DEVELOPMENT REVIEW COMMITTEE MEMORANDUM

**CASE NOS.: PC 25-21 Special Use Permit Planned Development
PC 25-22 Planned Development Concept Plan and
Final Plan**

**ARC 25-30 Village of Libertyville, Property Owner
200 E. Cook Ave**

Subject: **200 E. Cook Avenue – Municipal Police Station**
Request for Special Use Permit for Planned Development and simultaneous Concept Plan and Final Plan related to the Planned Development request

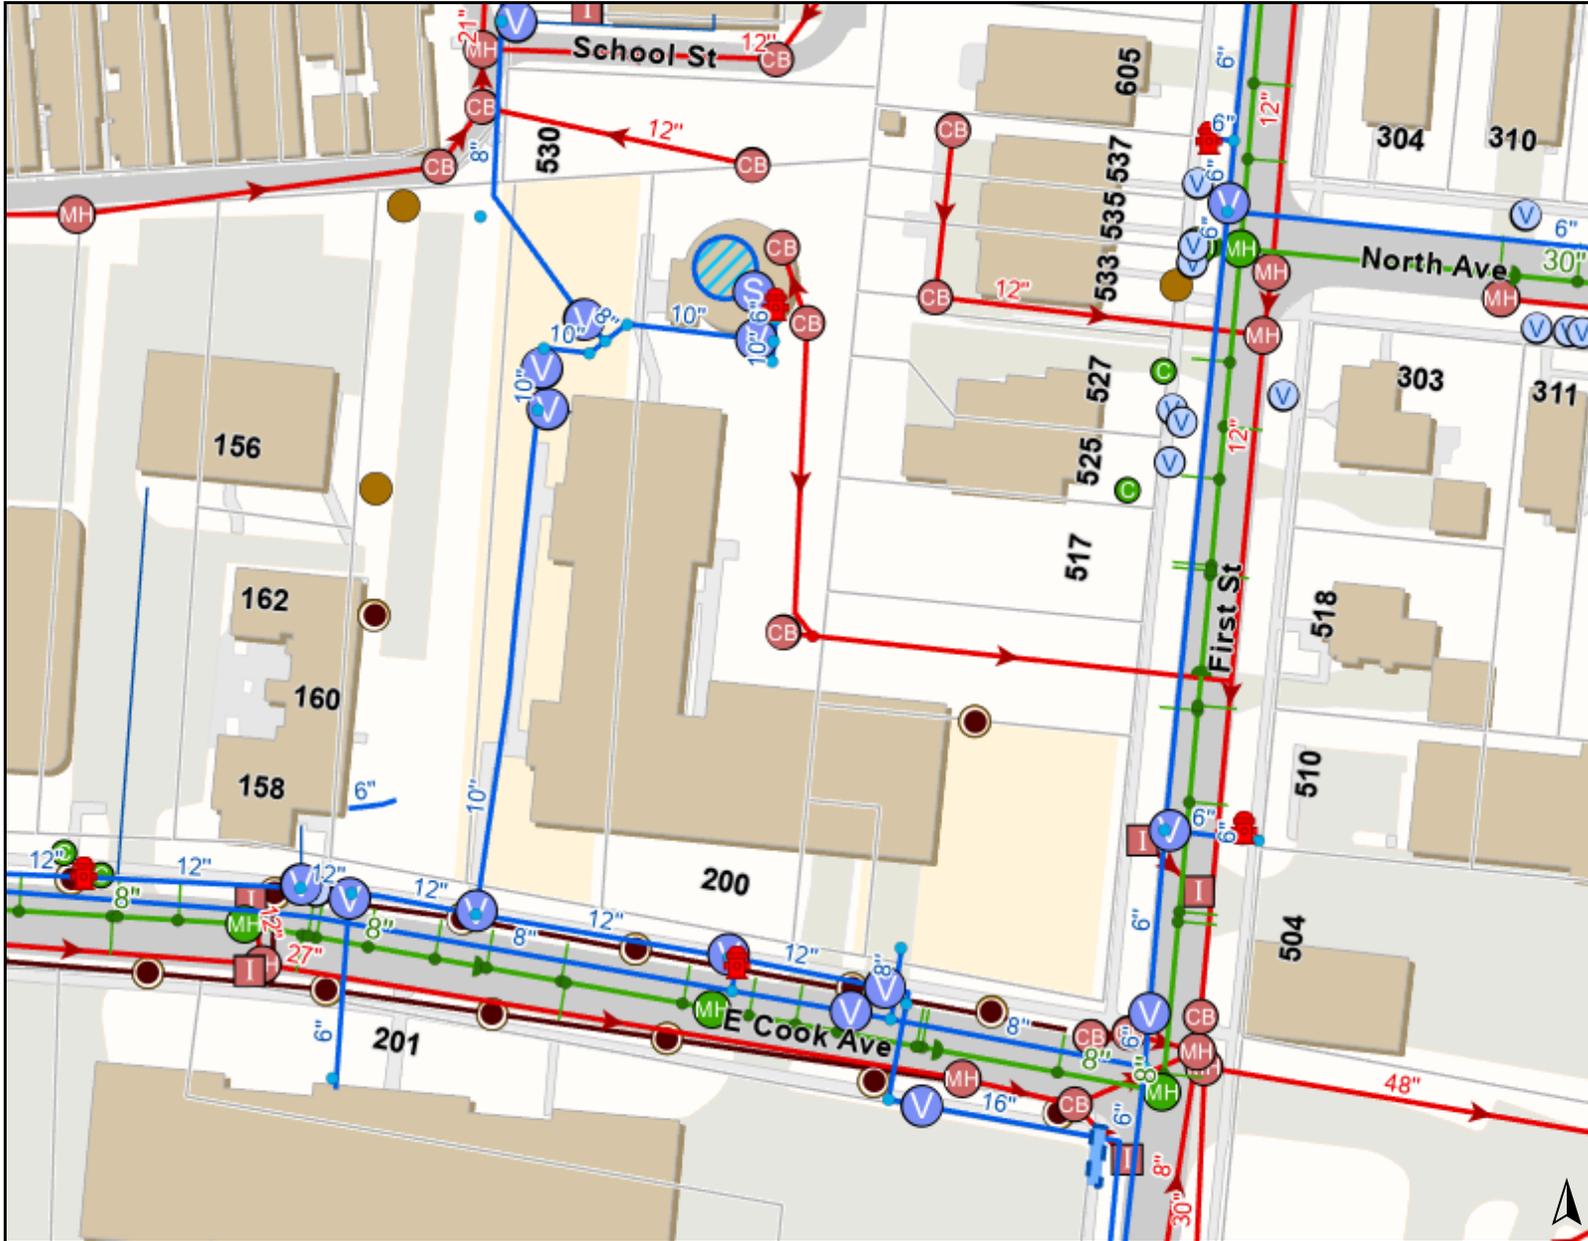
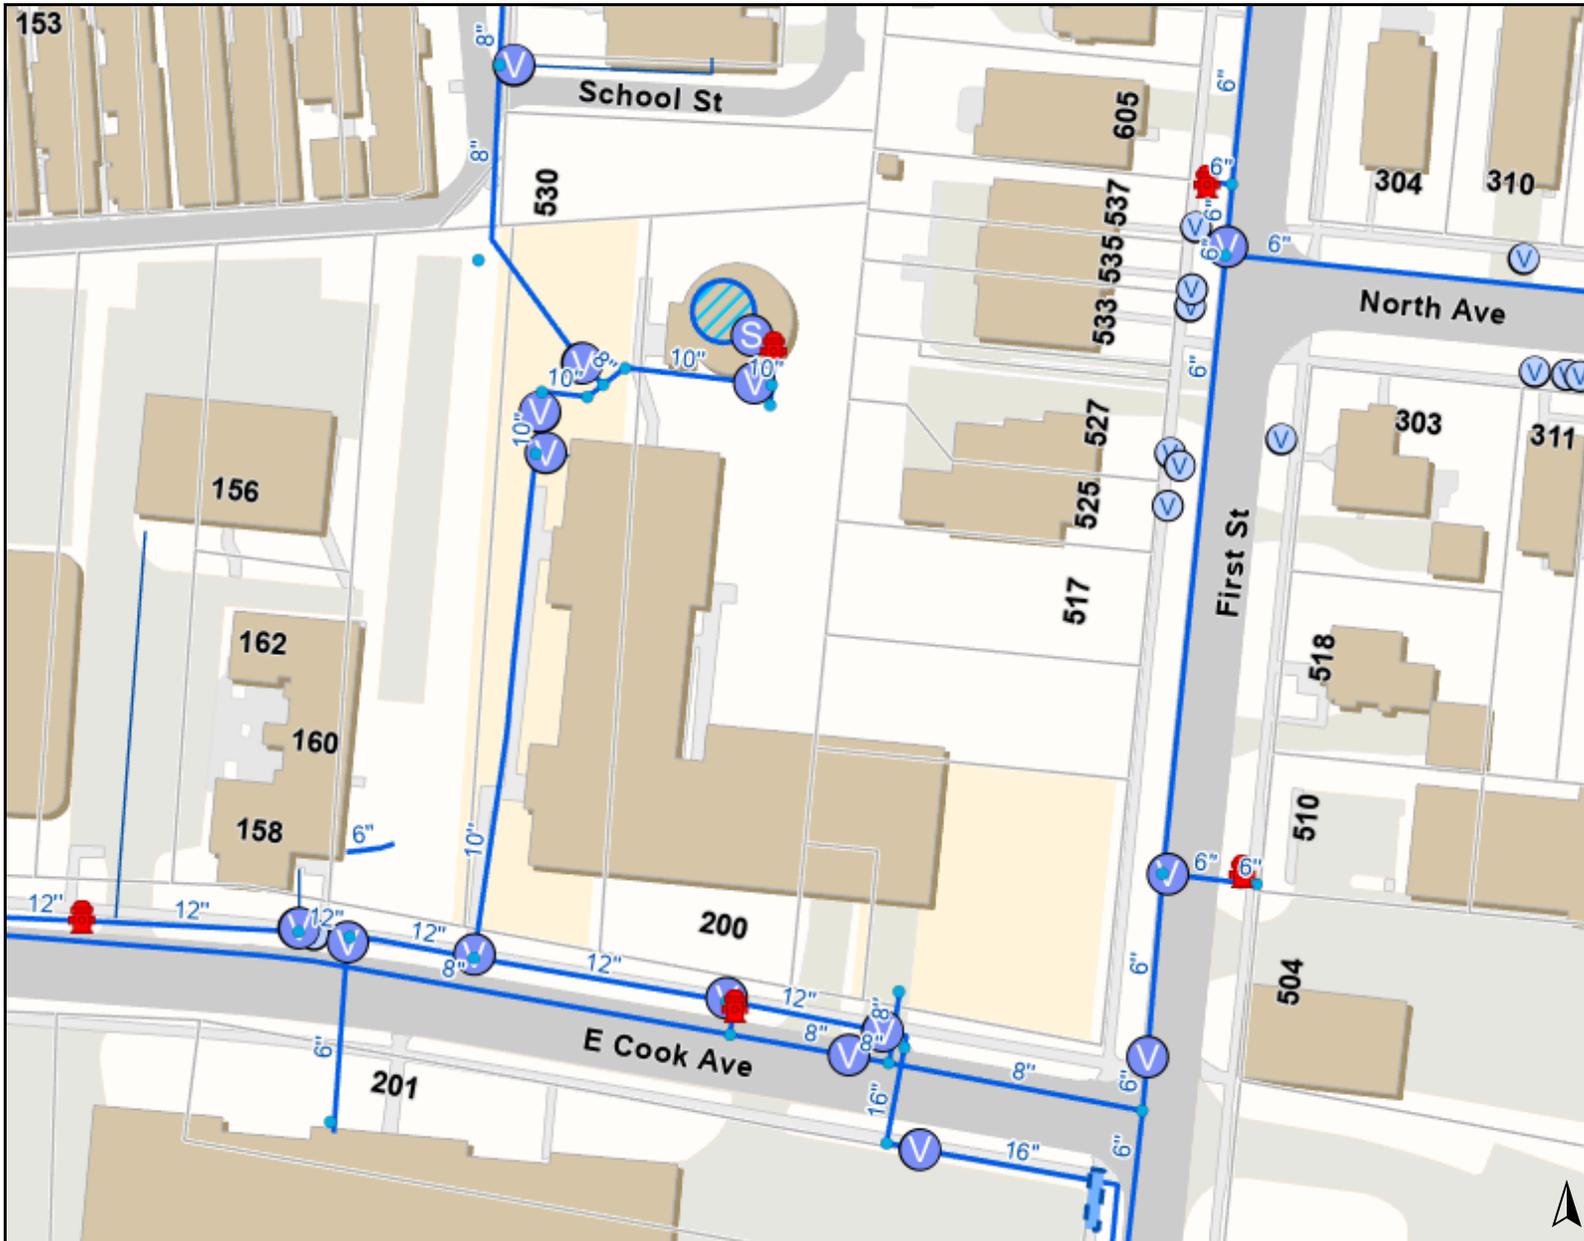
- a. The plans don't appear to be in complete agreement with Village records regarding the existing utilities in the right-of-way. A GIS exhibit is attached for reference, showing the approximate location of known facilities based on our records.
